SUBJECT: *Florida Rock Industries, Inc.*
Thomas S. Baker Cement Plant - Newberry
DEP File No. 0010087-018-AC
Finish Mill Throughput Increase

In response to your Request for Additional Information dated August 26, 2005, the following information is provided:

Re: Request for Additional Information
DEP File No. 0010087-018-AC
Finish Mill Throughput Increase

- COVERED-CLINKER- AND GYPSUM STORAGE -

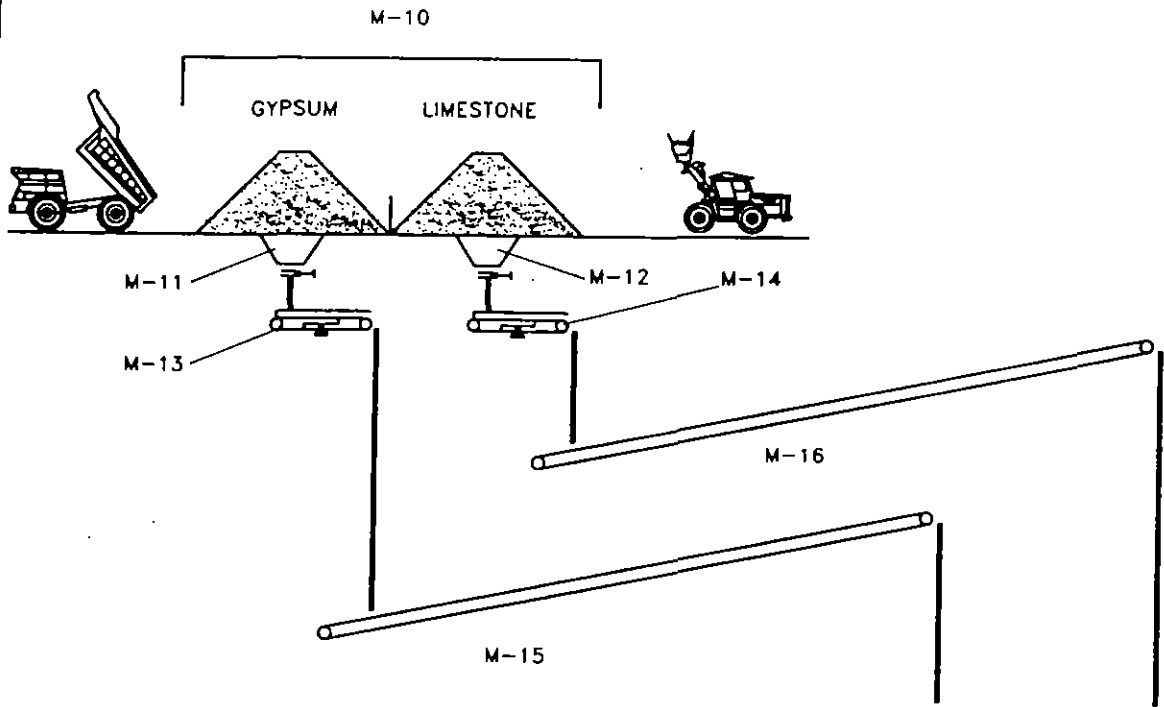
1. Regarding additional limestone transported from quarry to gypsum storage area:

Some amount of limestone will now be transported from the quarry to a silo in the gypsum storage area. The limestone, reportedly, will be "wet" coming from the quarry and FRI has assumed no added emissions of unconfined particulates associated with this activity. Estimate the amount of limestone to be transported and stored in the gypsum silo, and estimate the number of trucks needed for the movement of the limestone. Will there be appreciable amounts of fugitive dust as a result of the additional truck traffic and handling of the limestone? Describe in more detail the process by which the limestone will be transferred from the trucks to the gypsum silo. Describe how the existing gypsum silos will handle the "wet" limestone. Please provide diagrams of this process.

Limestone is already transported to this storage area, which is known as the "Covered Limestone and Gypsum Storage Area" that appeared on drawing page 8 of 14 submitted with the original Line 1 application. A copy of that page is attached. There is no silo.

Limestone is mined below or near the groundwater interface at this cement plant. The material is received in the plant with about 10% moisture. As shown by the attached drawing, the material is dumped from the truck into the storage area and out-loaded from storage into a hopper by front-end loader. No appreciable emissions will result from the handling as the result of the 10% moisture.
